Access Compliance Report

Public Rights-of-Way

Intersection ID: 2949	Main Street: DOWNFIELD_WOOD_DR	Cross Street: LADY_BANK_DR	Location:	N
ADA ID: D02734D730AB	Ramp Type: Perp	Initial Pass/Fail: Fail	Overall Compliance: No	Severity Score: 22.5
Codes/Mitigation Info/Possible Solution		Field Measurements/Component Compliance

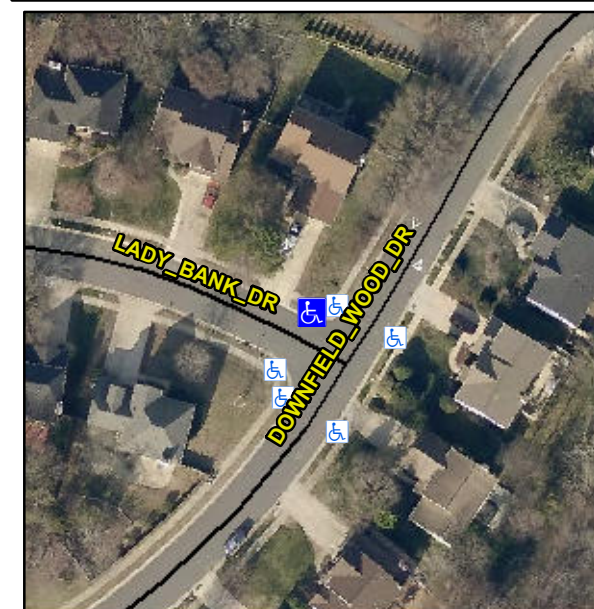
R304.5.1, R304.2.2, R304.5.3

Compliance	Description	Data	Compliance	Description	Data
N/A	Ramp Length (in)	49.0	No	Ramp Slope (%)	11.1
No	Ramp Width (in)	47.0	No	Ramp XSlope (%)	4.7
N/A	Flare Type LT	N/A	N/A	Flare Type RT	N/A
N/A	Flare Slope LT (%)	N/A	N/A	Flare Slope RT (%)	N/A
N/A	Flare Traversable LT?	N/A	N/A	Flare Traversable RT?	N/A
N/A	Landing Length (in)	N/A	N/A	DWS Provided?	N/A
N/A	Landing Width (in)	N/A	N/A	DWS Contrast?	N/A
N/A	Landing Slope (%)	N/A	N/A	DWS Length (in)	N/A
N/A	Landing X Slope (%)	N/A	N/A	DWS Full Width?	N/A
N/A	Landing Curb? (Y/N)	N/A	N/A	DWS Offset (in)	N/A
N/A	Shared Landing?	N/A			
N/A	Gutter Ponding?	N/A	N/A	Gutter Slope (%)	N/A
N/A	Gutter Lip Ht (in)	N/A	N/A	Gutter X Slope (%)	N/A
N/A	Painted X Walk1?	No	N/A	Painted X Walk2?	N/A
	X Walk 1 Direction	To SW		X Walk 2 Direction	N/A
N/A	X Walk 1 Width (in)	N/A	N/A	X Walk 2 Width (in)	N/A
	X Walk 1 Slope (%)	3.3		X Walk 2 Slope (%)	N/A
	X Walk 1 X Slope (%)	2.0		X Walk 2 X Slope (%)	N/A

Remove & Replace Entire Ramp.
